Stormwater Report for:

River Heights Estates Short Plat Skamania County, Washington

RE: River Heights Estates Short Plat (SP-07-04)

This letter is being written as an addendum to the stormwater report for the River Heights Estates Short Plat. It is intended to clarify sizing requirements for the individual roof infiltration facilities for the future home to be constructed.

Typical Roof Infiltration System
MIS

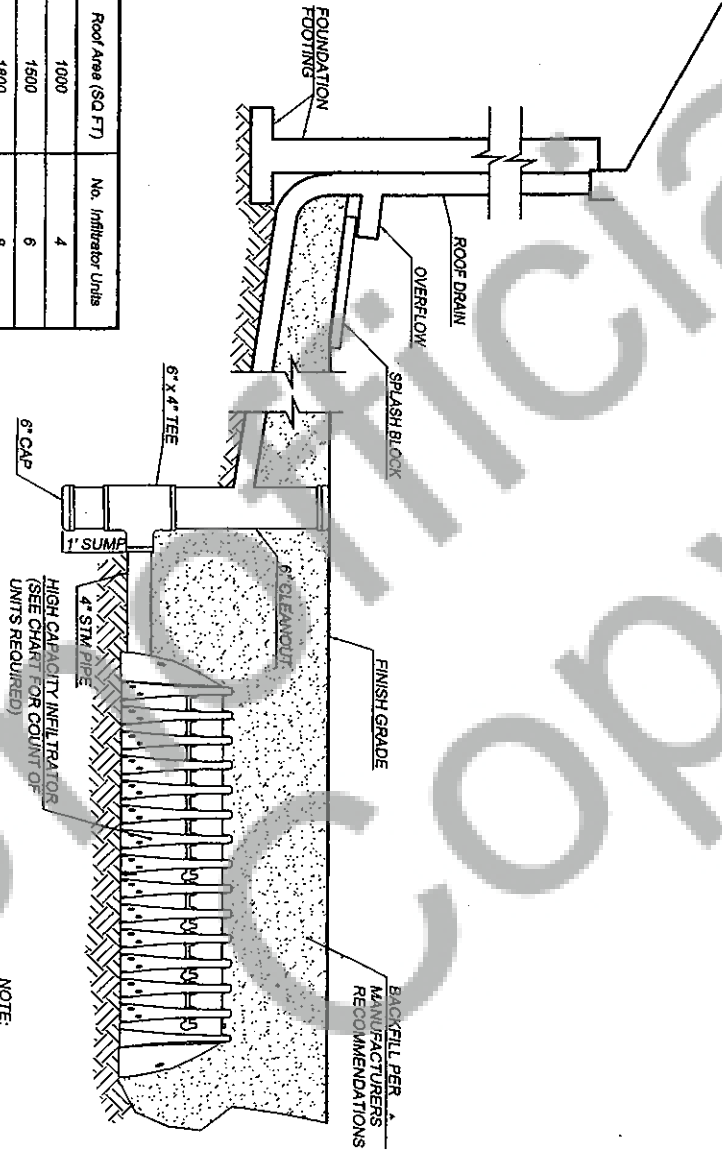
- 1) ~~Include Unit Map~~
- 2) ~~Include reduced 11x17" or 8 1/2" x 11" plat map~~
- 3) Add Roof Areas
 - a) 2,000 ☒ see letter
 - b) 2,500 ☒
 - c) 3,000 ☒

As can be seen in Appendix A of the report, modeling calculations have been completed for 1,000, 1,500, and 1,800 sq-ft roof areas. These models were intended to allow for individual infiltration facilities to be constructed based on a contributing drainage area to each facility. For instance, if a new home is to be constructed with a 2,000 sq-ft footprint the infiltration facility could be constructed as one facility consisting of 8 Infiltrator units (4 units/1,000 sq-ft) or two separate facilities consisting of 4 Infiltrator units each. This allows the roof runoff to be directed to separate locations if needed (i.e. - the front of the house and the back of the house). This also allows for the construction of a detached garage or shop as a separate facility if so desired. If you have any questions please feel free to call me at (360) 431-9988.
